MEETING NOTICE AND AGENDA

- d. Award of Bid for the construction of a 1.0MG Water Tank located above the Orchard Ridge development, and construction inspection services – Public Works.

KAYSVILLE CITY COUNCIL
February 20, 2020

PP4

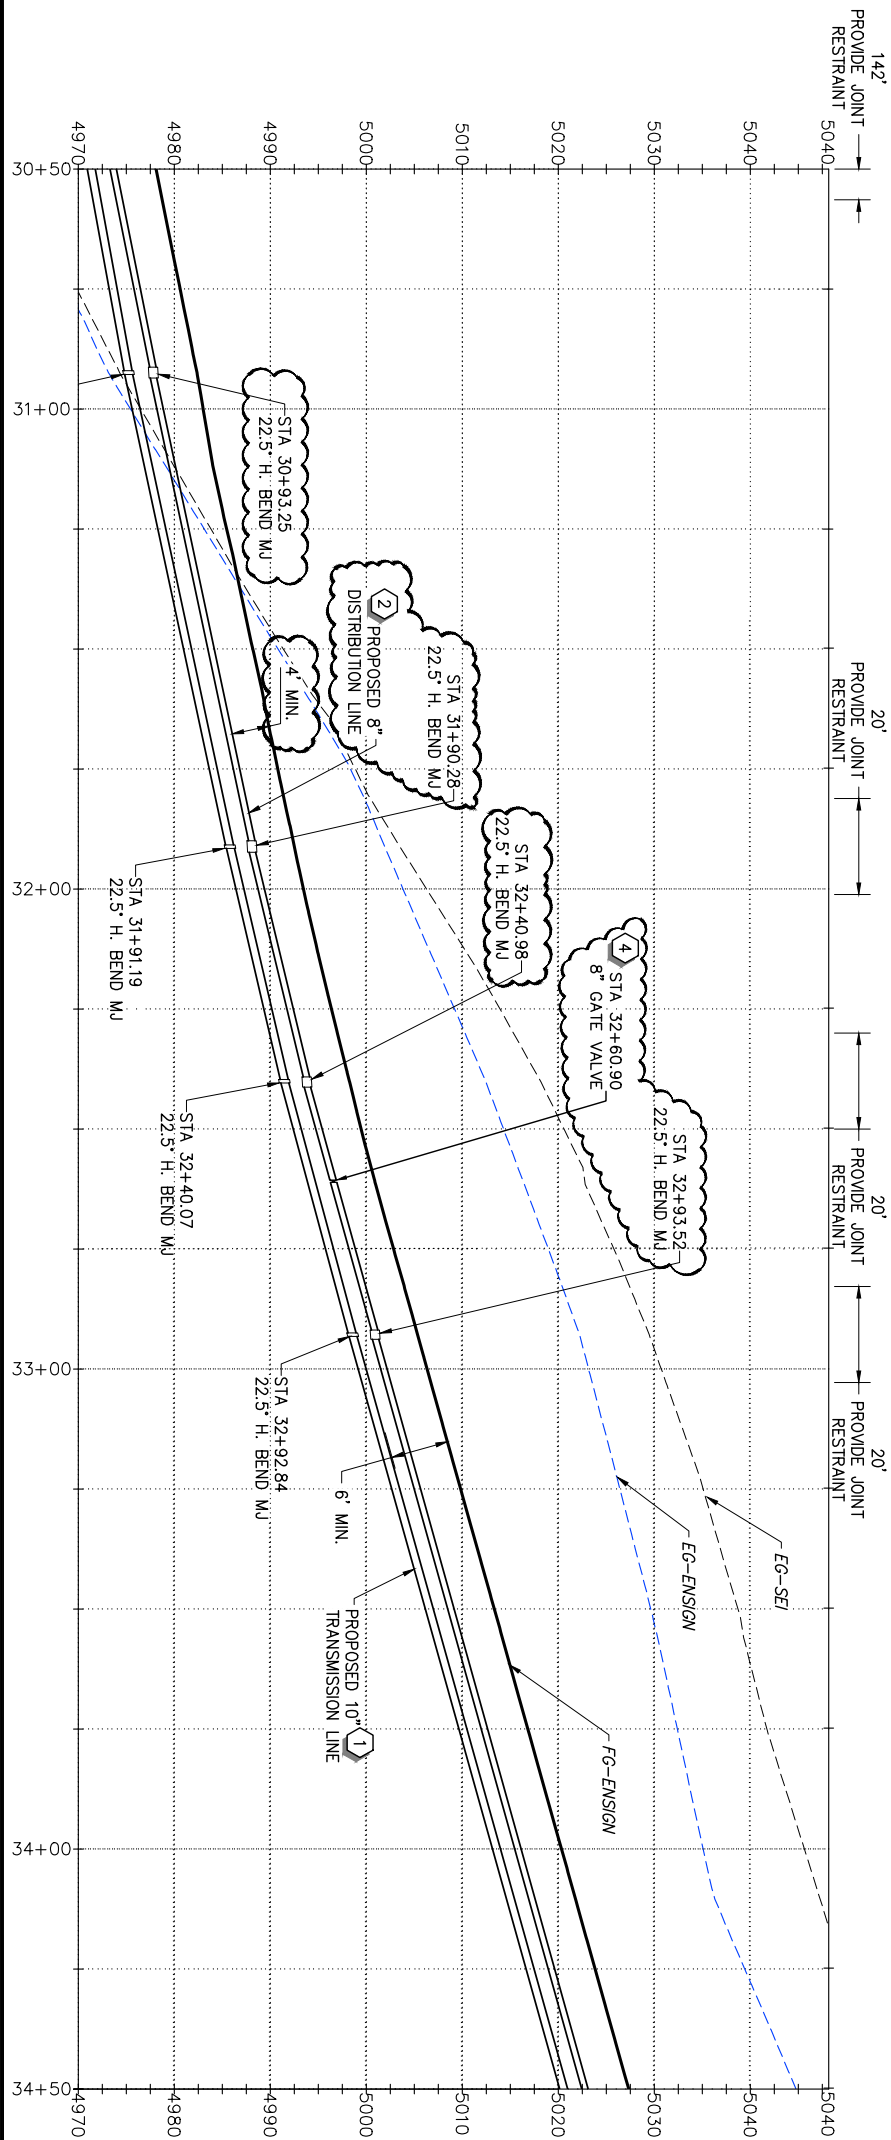
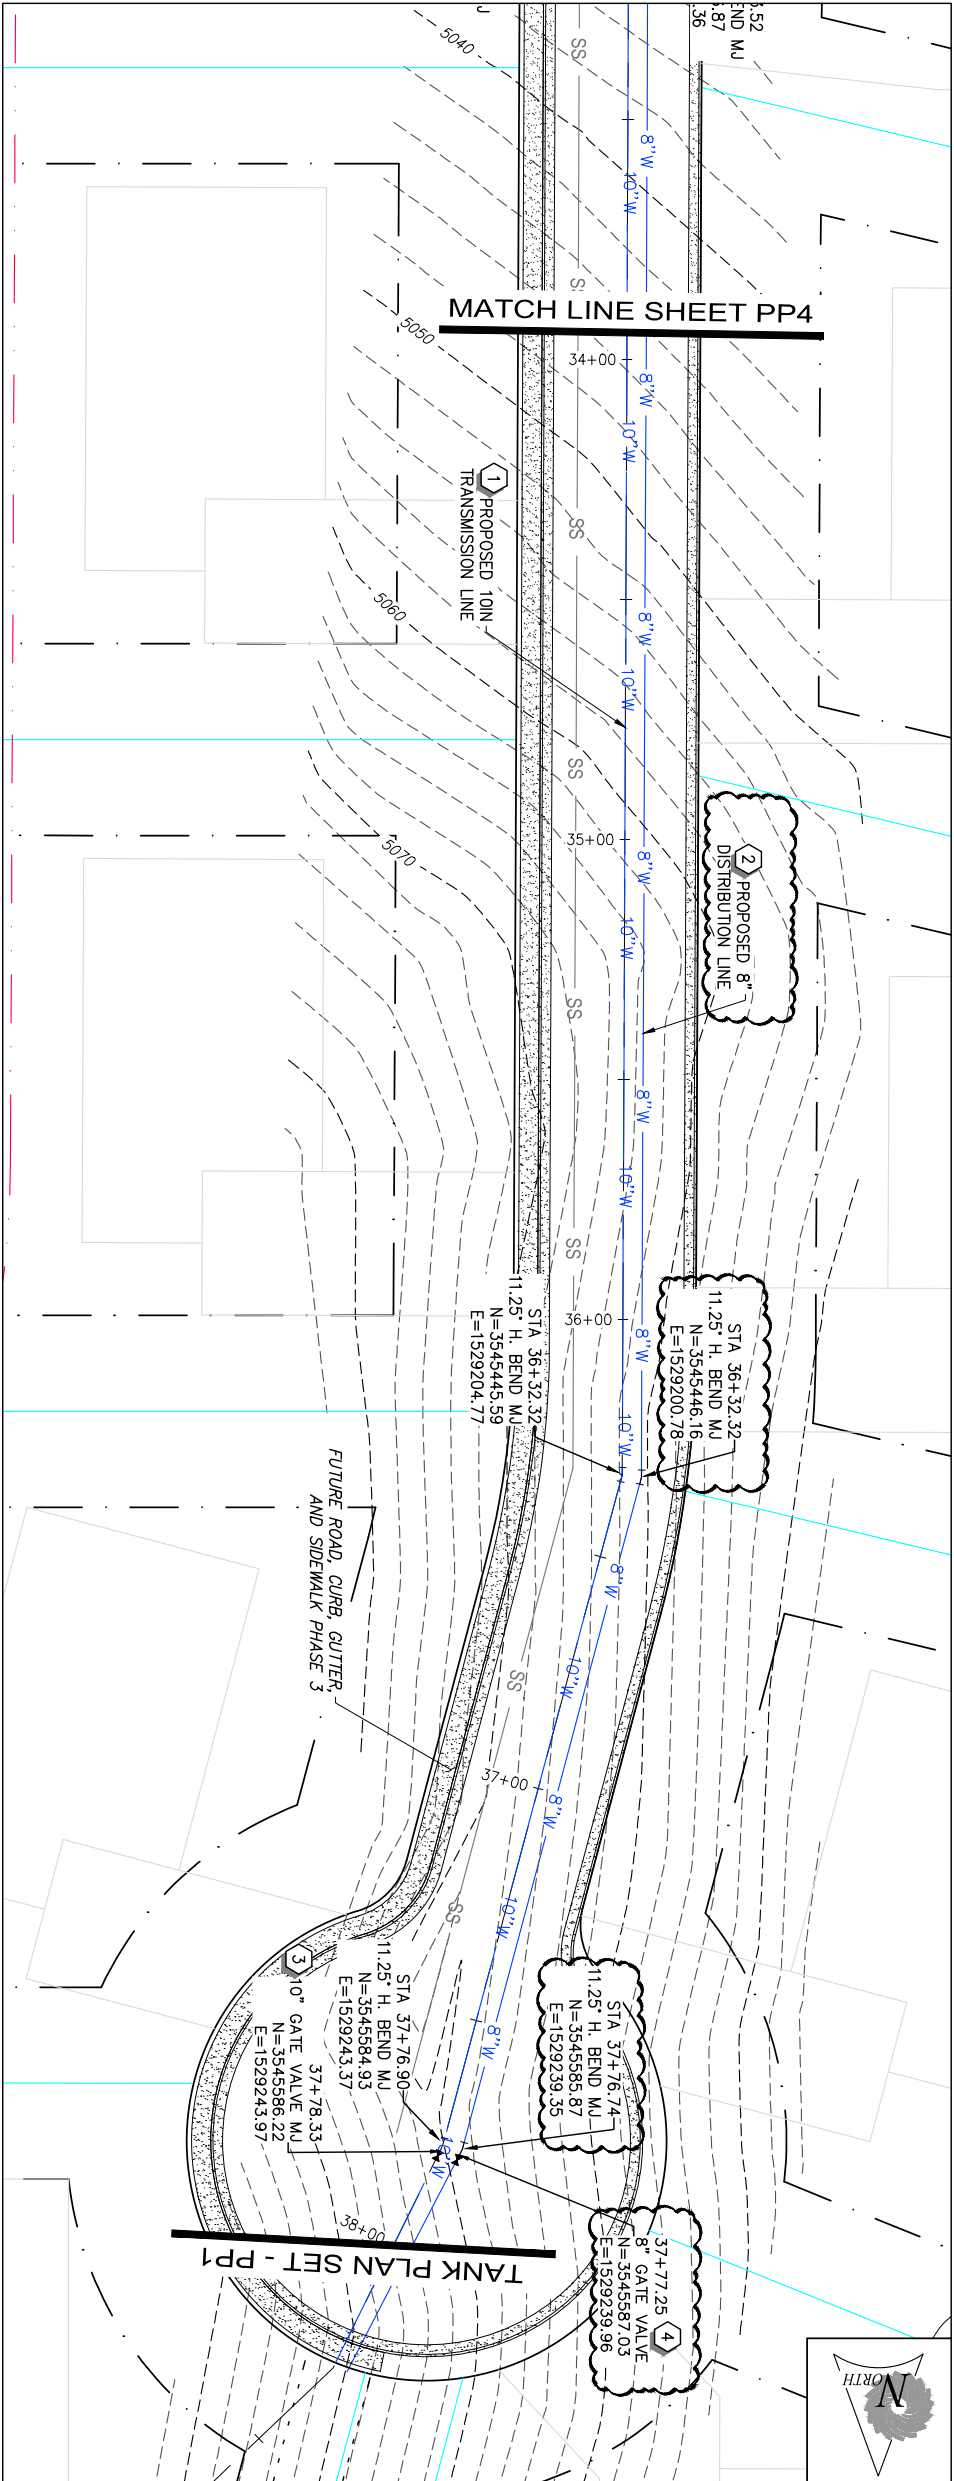
4.4 Revised Sheet PP4 of Booster Station Project
